DEPARTMENT OF TRANSPORTATION

[Docket No. FAA-2020-0883; Project Identifier 2019-CE-034-AD; Amendment 39-21460; AD 2021-05-17]

Airworthiness Directives; Rockwell Collins, Inc. Flight Display System Application

ACTION: Final rule.

Figure 1 to paragraph (g)(1)(iii); placard location on bezel

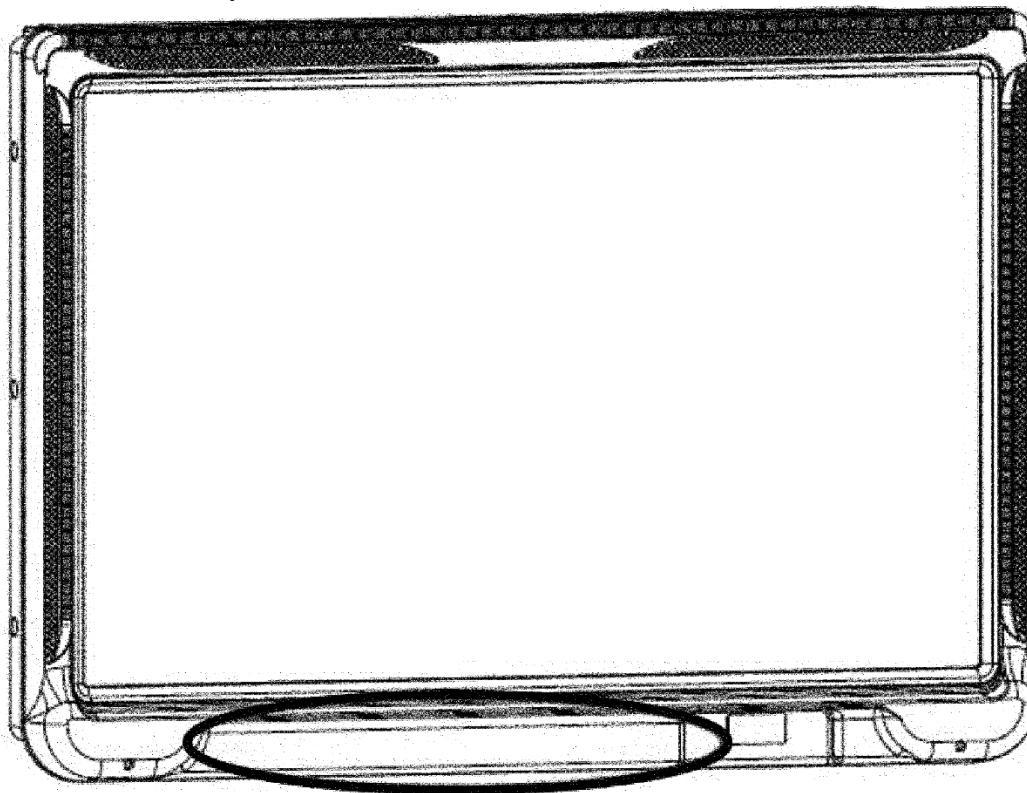
(iii) Install the placard on the bottom of each aircraft primary flight display bezel in the area depicted in figure 1 to paragraph (g)(1)(iii) of this AD.
